Site Allocations DPD

MSDC-09: Response to Action Point 10

Matter 3.3: SA28: Land south of The Old
Police House, Birchgrove Road, Horsted
Keynes

Project No: ITB15584
Project Title: Birchgrove Road, Horsted Keynes
Title: MSDC Allocations DPD Examination – Site SA28 Access Summary Note
Ref: ITB15584-001 TN
Date: 14 June 2021

Image 2.2: Extent of Root Protection Area

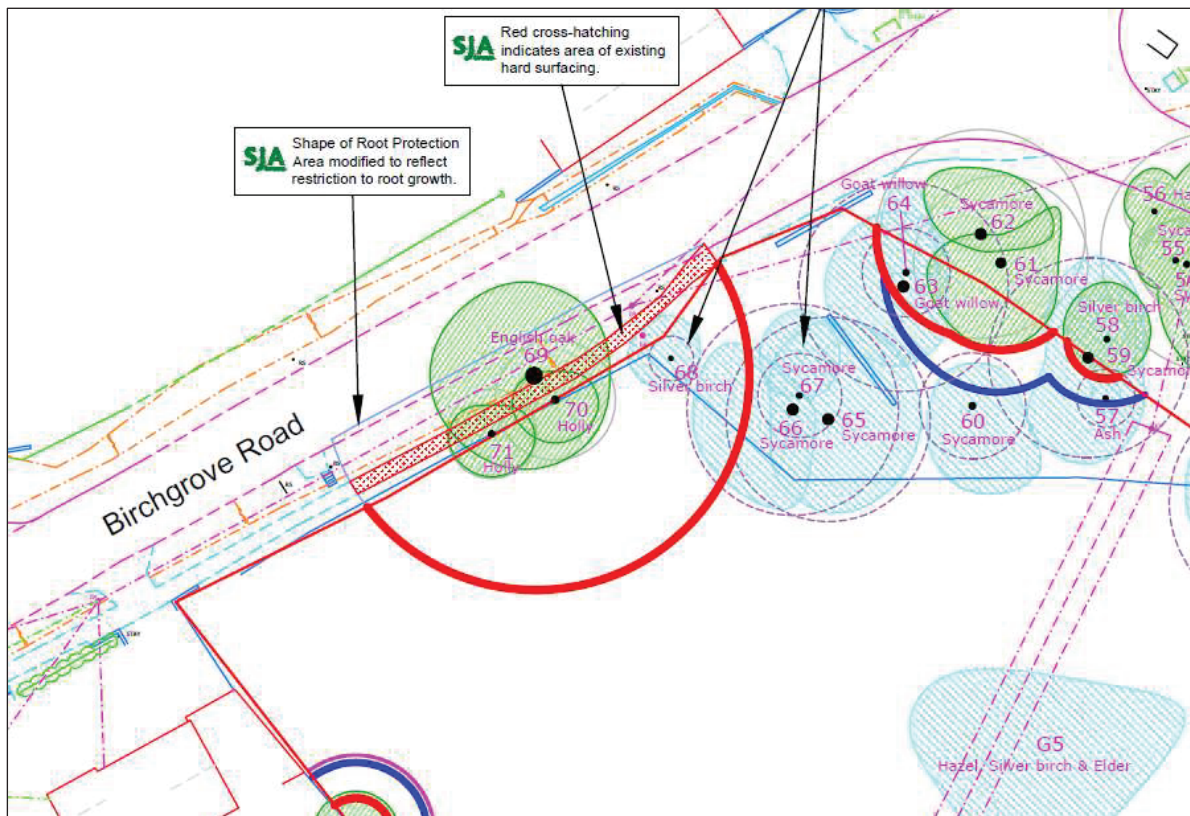
2.1.3 The extent of the Root Protection Area (RPA) associated with the Oak is shown in **Image 2.2**.

2.1.4 As identified by the Tree Survey, the Oak is not an excellent specimen, as reflected by its 'B' categorisation, and is in a poor physiological condition. Notwithstanding, Sunley recognise that the Oak has a role to play in the local street scene and that its retention would be beneficial.

Image 3.2: Preliminary Access Arrangement

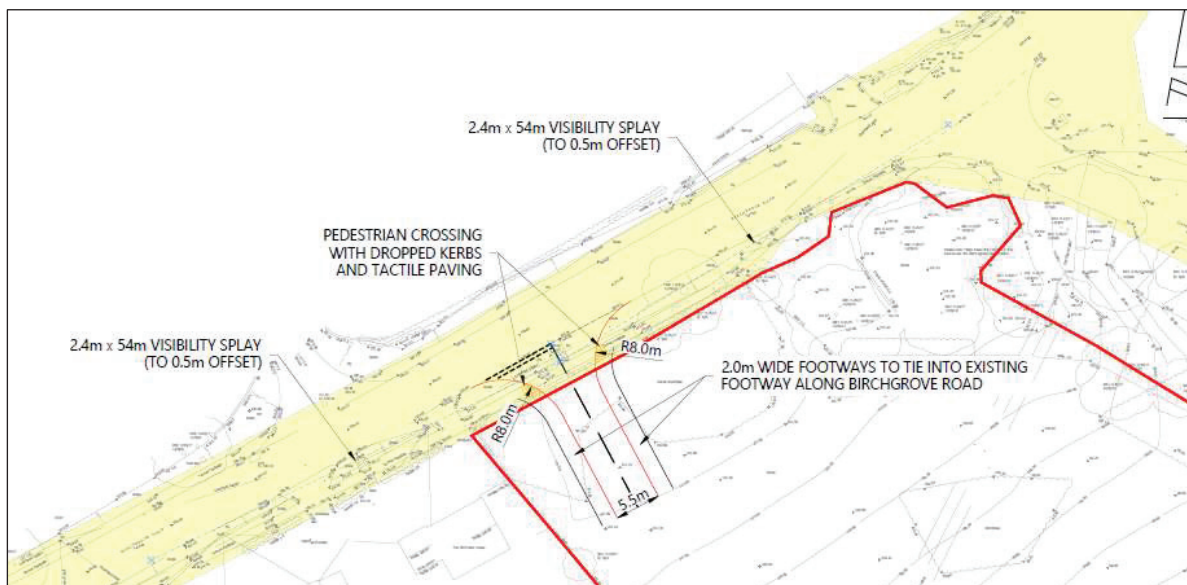
4.2.1 Visibility splays extending 54m have been identified from the site access; as demonstrated in Drawing ITB15584-GA-002, the extent of the splay is situated in front of the trunk of the Oak tree, and the tree does not present an obstruction to the visibility available to emerging drivers.

4.2.2 In accordance with contemporary highway design guidance, the visibility splay is required to be kept clear obstructions below the height of 2m. As identified in the Tree Survey summarised in Section 2, the Crown commences at 2m, and thus does not obstruct visibility.

Image 4.4: Access and RPA Overlay

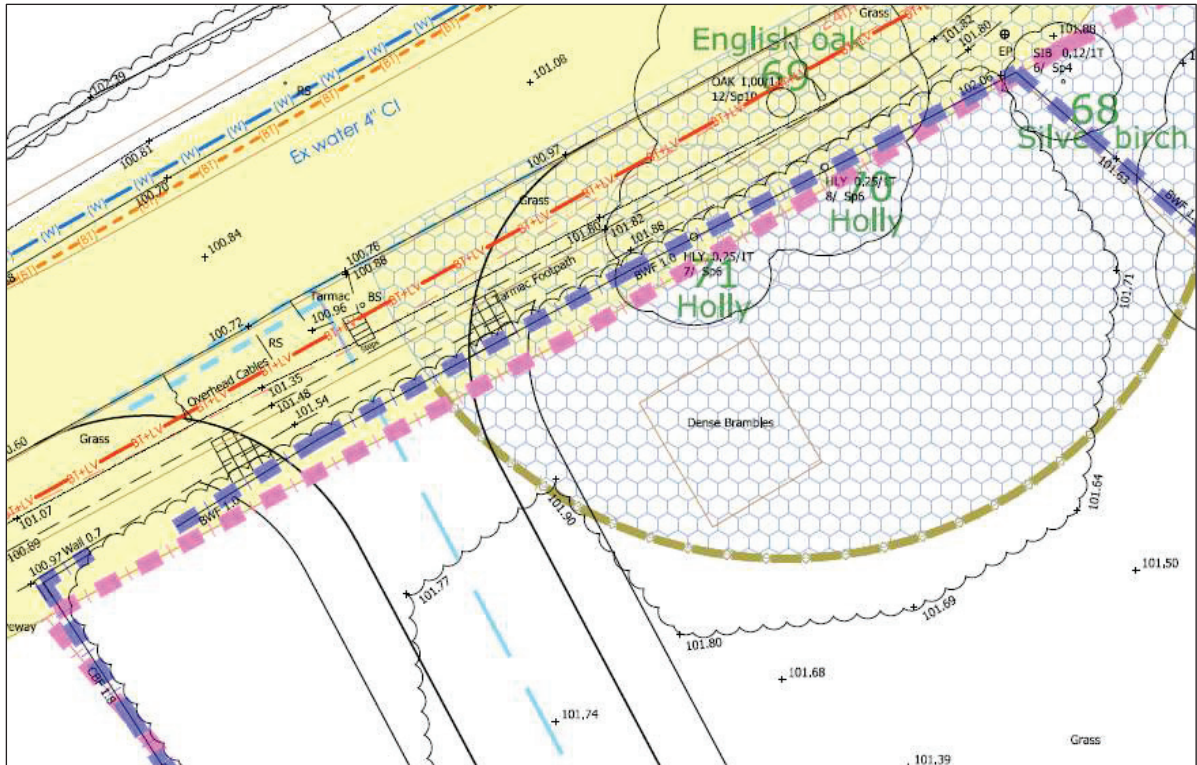
4.3.4 An overlay of the preliminary access arrangements and the RPA identifies that there is potential for the access to encroach within the RPA – this overlay is shown at **Image 4.4**, with the blue hatching denoting the extent of the RPA.

4.3.5 However, there are a number of means of mitigating the impact that will be explored as part of any future planning application.

4.3.6 In the first instance, the preliminary access will be refined in order to remove or minimise any incursion into the RPA.

4.3.7 The preliminary access identifies a carriageway width of 5.5m, suitable for 2 large vehicles (e.g. servicing vehicles) to pass one another. While this is typically a 'starting point' for contemporary highway design, such a width would not be necessary to accommodate the needs of a residential development such as that proposed – the likelihood of 2 HGV's required to pass one another on a residential site is low. For comparison, Manual for Streets identifies a carriageway width of 4.8m being a sufficient width to which to accommodate a car passing a larger vehicle. The proposed internal footways can be

narrowed in width, so that they are more consistent with the existing provision on Birchgrove Road, or only provided on the western side of the access road to complement the pedestrian desire line.

- 4.3.8 Utilisation of an alternative pedestrian arrangement would also reduce the extent of the encroachment into the RPA, with construction of a new footway outside of the RPA. The existing footway could be returned to verge to the benefit of street scene upon entry into the village.
- 4.3.9 The location of the access can also be positioned slightly further to the west while retaining the requisite visibility splays, and this would have the effect of further reducing the encroachment into the RPA.

- 4.3.10 As the tree is not classified as being a veteran tree, in the event that an area of hard surface is required within the RPA, then an alternative construction technique can be used should detailed investigation of the RPA identify that standard construction techniques could result in the loss of rooting that is harmful to the tree.

- 4.3.11 In this instance, a 'no-dig' specification can be used, consistent with that recognised in Section 7.4 of BS5837:2012 *Trees in Relation to Design, Demolition and Construction – Recommendations*. BS5837 cautions that no more than 20% of the currently unsurfaced RPA should be covered in new hard surface. In this instance, the area of new hard surfacing would be well below this 20% even before any refinement to the access arrangement. An extract of the relevant section of BS5837:2012 is provided at **Appendix A**.
